VALIDATION REPORT

Inner Mongolia Mangniuhai II Wind Power Project in China

REPORT No. 2009-1346

REVISION No. 03

Table 4 Yearly Average Wind Speed from Tuquan Station from 1972 to 2009

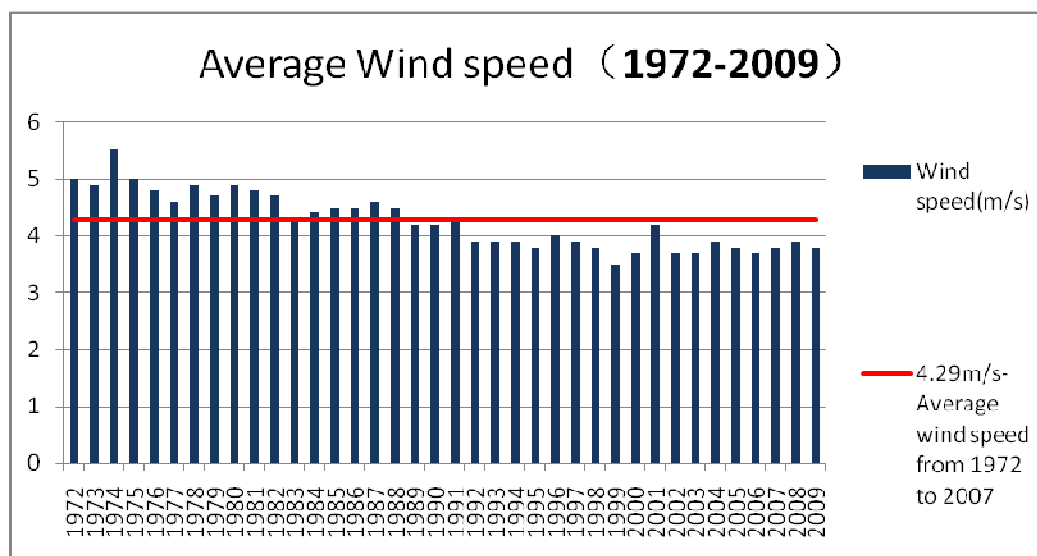
According to the guidance of VVM version 1.1 paragraphs 109 and 110 /9/, the suitability of estimated PLF for the proposed project has been further substantiated below, According to the FSR /4/, the average wind speed over 35 years is calculated to be 4.29 m/s. The wind speed after 1990 is almost lower than the average wind speed. In order to validate the suitability of PLF, the data in 2008 and 2009 /78/ has been requested to be provided so as to demonstrate whether the actual wind speed is in line with the trend. As shown in the table 4, the actual average yearly wind speed is slightly lower than the average wind speed.

From the table above, it can be found that the yearly average wind speeds in 2008 and 2009 are lower than the average wind speed of 4.29 m/s. Therefore, it is able to conclude that the PLF described in the FSR /4/ based on the data during 1972 and 2007 is conservative and reasonable.
